Minor Development Staff Report

DATE: DECEMBER 27, 2024
TO: DOUGLAS COUNTY BOARD OF COUNTY COMMISSIONERS
THROUGH: DOUGLAS J. DEBORD, COUNTY MANAGER
FROM: TERENCE T. QUINN, AICP, DIRECTOR OF COMMUNITY DEVELOPMENT 
CC: BRETT THOMAS, AICP, CHIEF PLANNER
JEANETTE BARE, AICP, PLANNING MANAGER
STEVEN E. KOSTER, AICP, ASSISTANT DIRECTOR OF PLANNING SERVICES
SUBJECT: RETREAT AT PERRY PARK, FILING 1 – MINOR DEVELOPMENT

PROJECT FILE: SB2023-034

RETREAT AT PERRY PARK - FILING NO.1

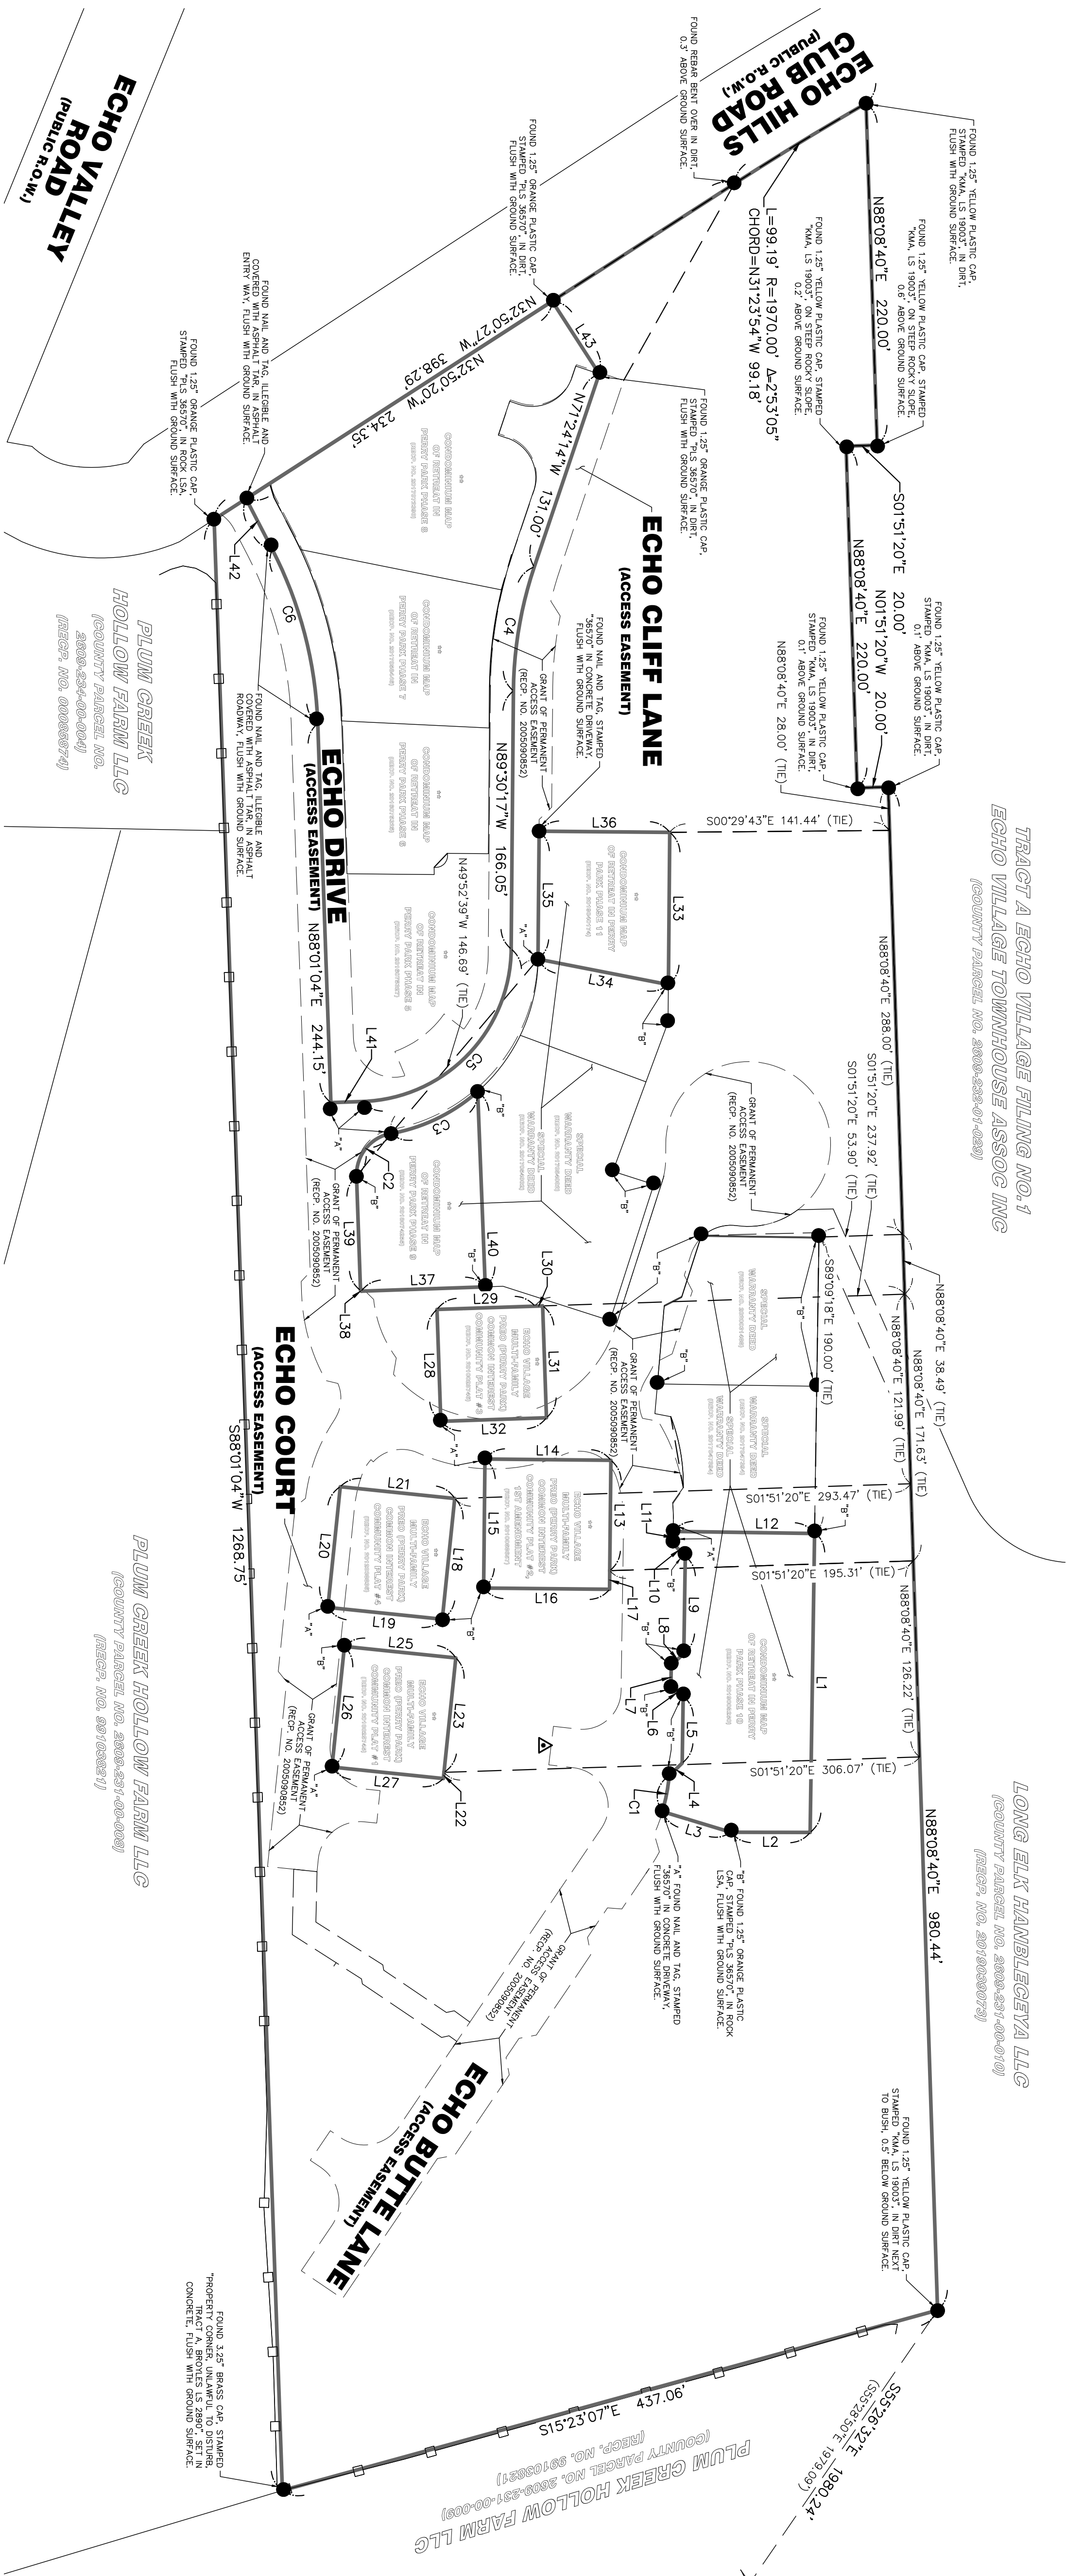
ADD A 10-FOOT EASEMENT FOR THE EXISTING CORE UG FACILITIES
(INCLUDE EASEMENT WITH ACCESS EASEMENT)

RETREAT AT PERRY PARK - FILING NO.1
SHOWING
ECHO VILLAGE MULTI-FAMILY - RETREAT IN PERRY PARK
LARKSPUR, COLORADO, 80118
SHEET 4 - DETAIL SHEET

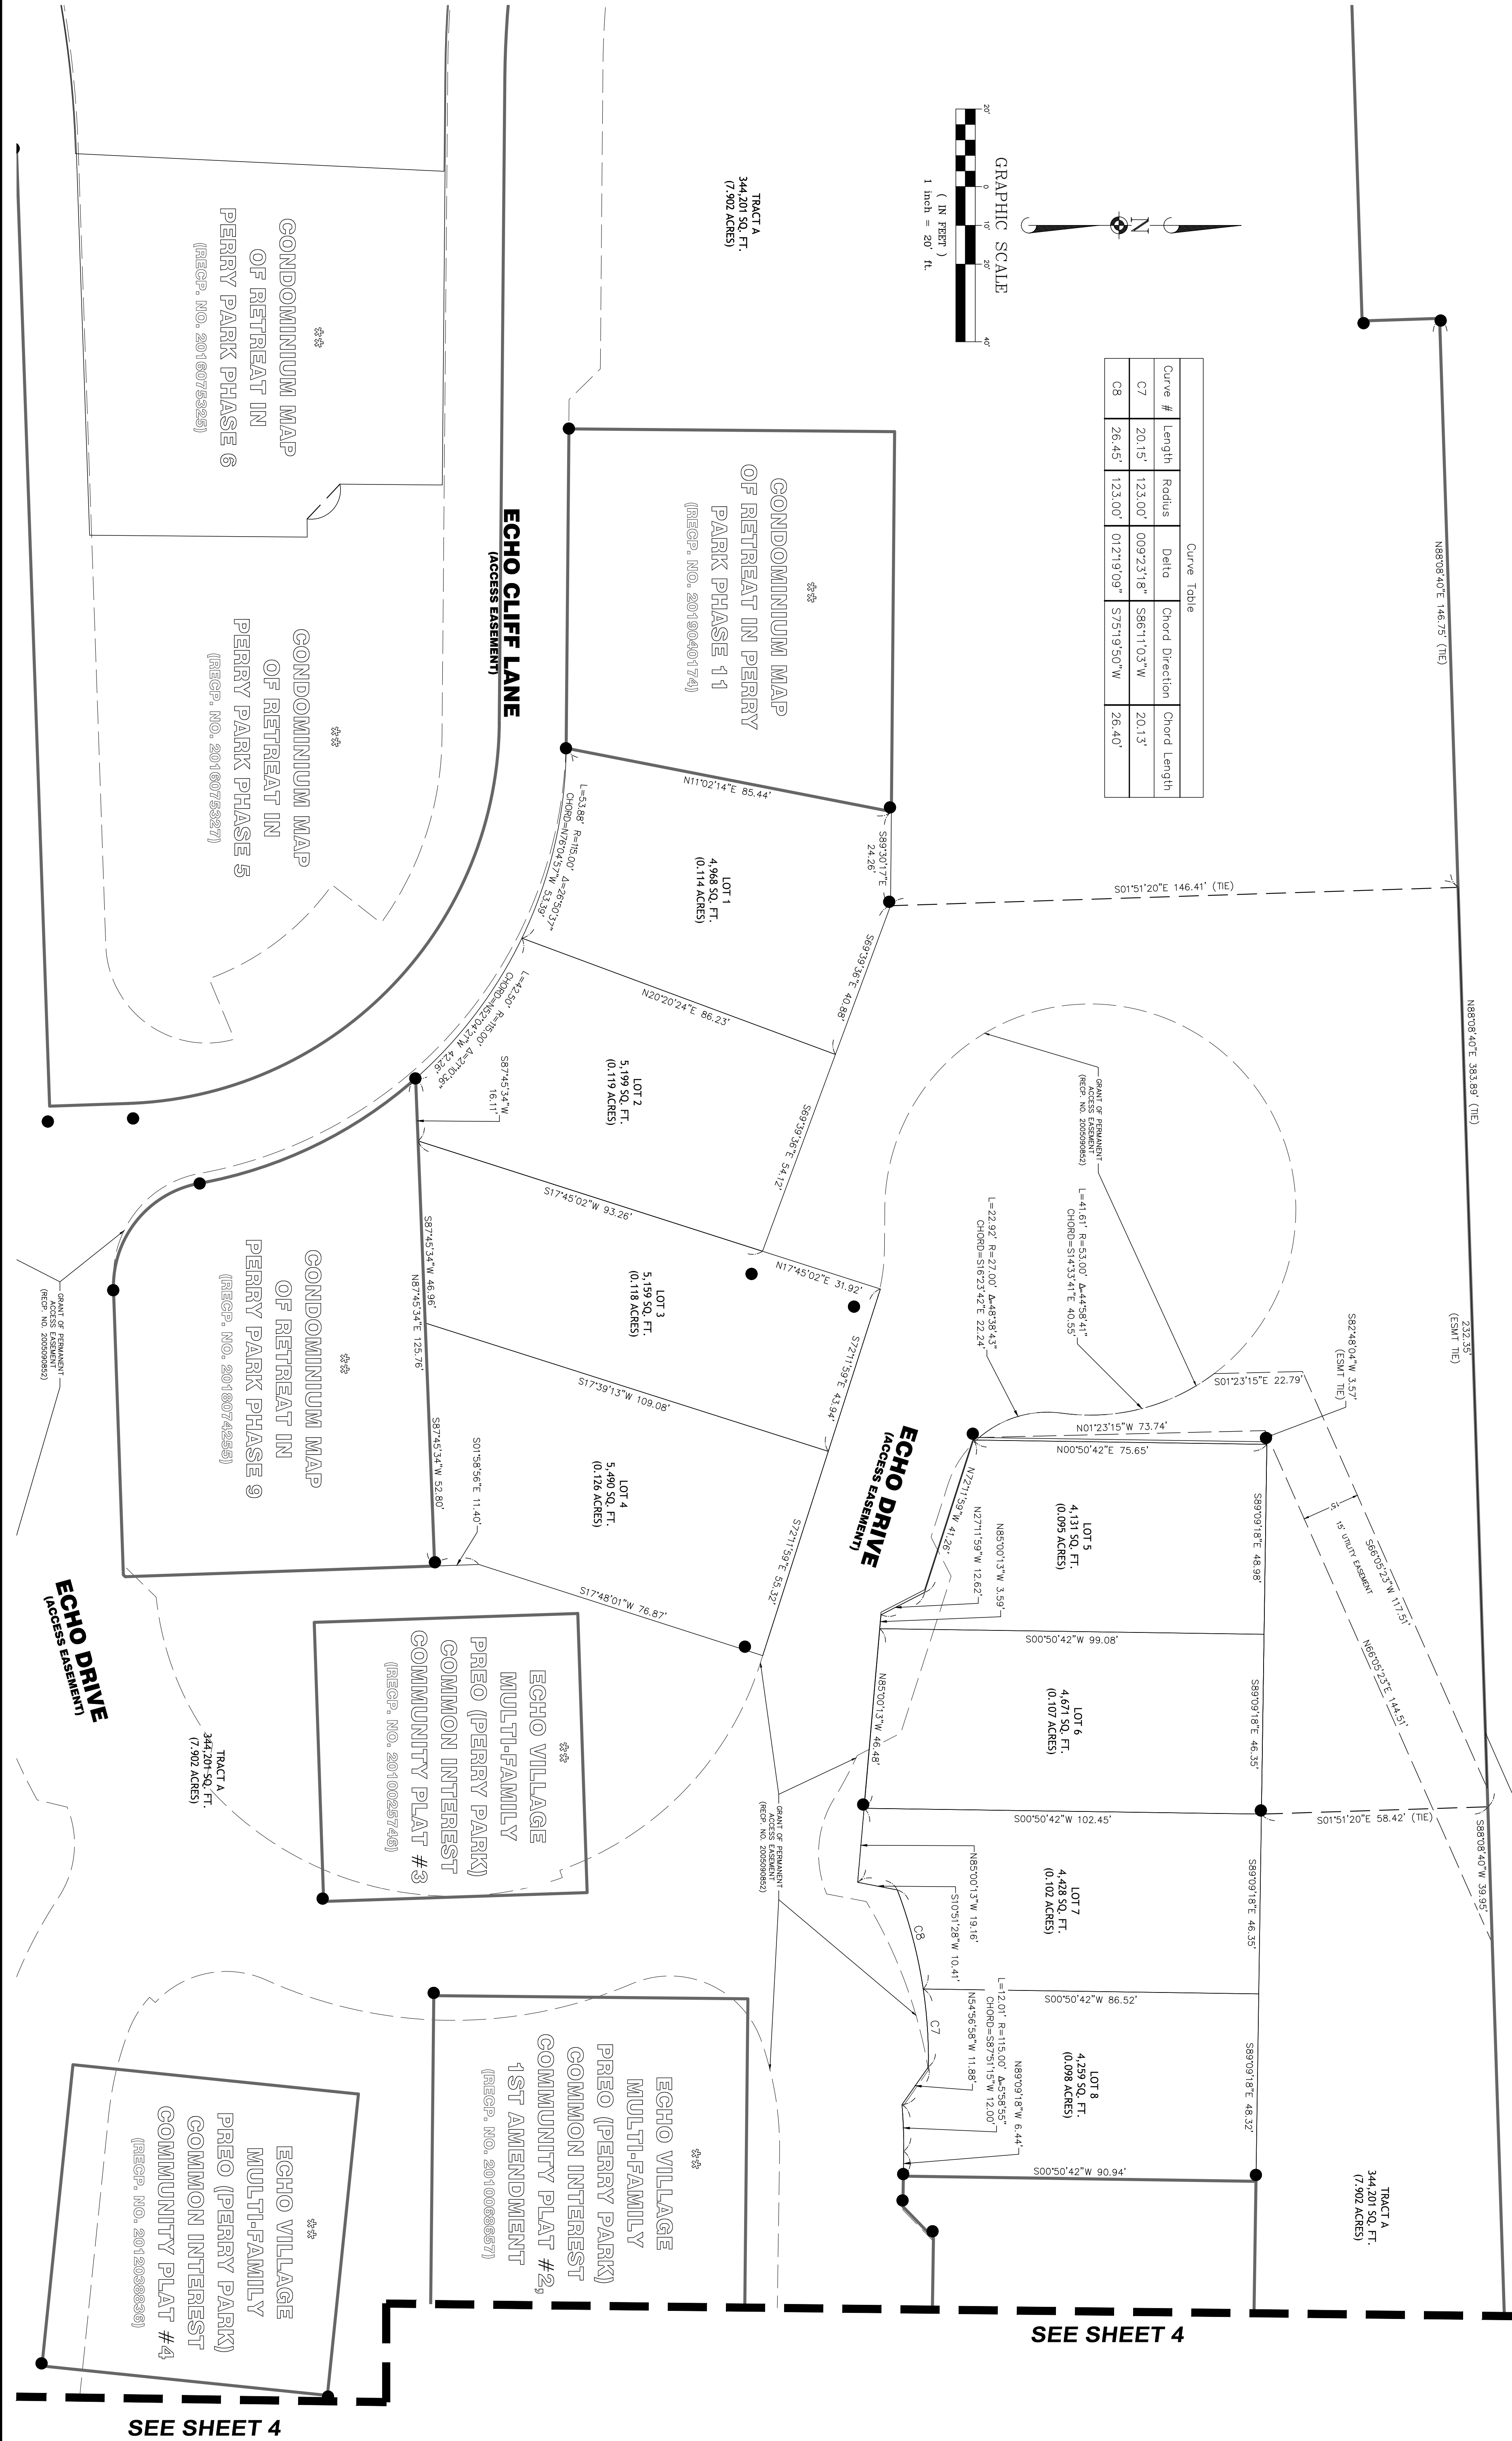
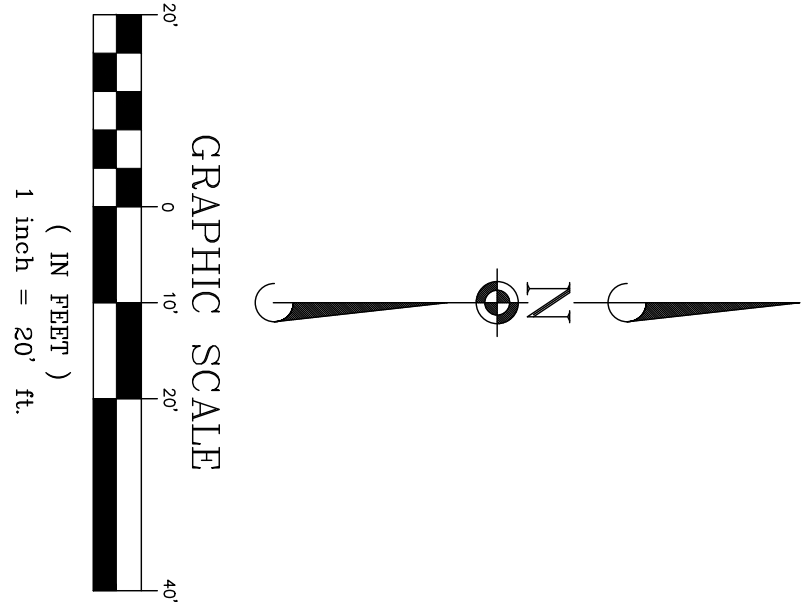
CGS is concerned about the condition of the existing retaining wall below the easternmost building site on the south side of Echo Butte Lane (Lots 17 and 18 as shown on Sheet 4 of the 1/30/2023 plat by CWC). The retaining wall exhibits evidence of ground movement; I observed separation between several rows of blocks in the western corner of the upper retaining wall, indicating differential settlement or slope movement on a larger scale. I am concerned about the potentially destabilizing effect of loading (a duplex structure is proposed above the wall), landscape irrigation, and concentrated infiltration from roof runoff. An increase in soil and bedrock water content generally causes a decrease in strength and stability. **CGS recommends that the county require an analysis of retaining wall stability in this area and, if necessary, repair or reconstruction.**

Staff Comment: The CGS recommended the County require an analysis of retaining wall stability. Tests were performed and the applicant is repairing and reconstructing walls as recommended by the reports. Standard geotechnical explorations of individual building sites will be required as part of the building permit process.
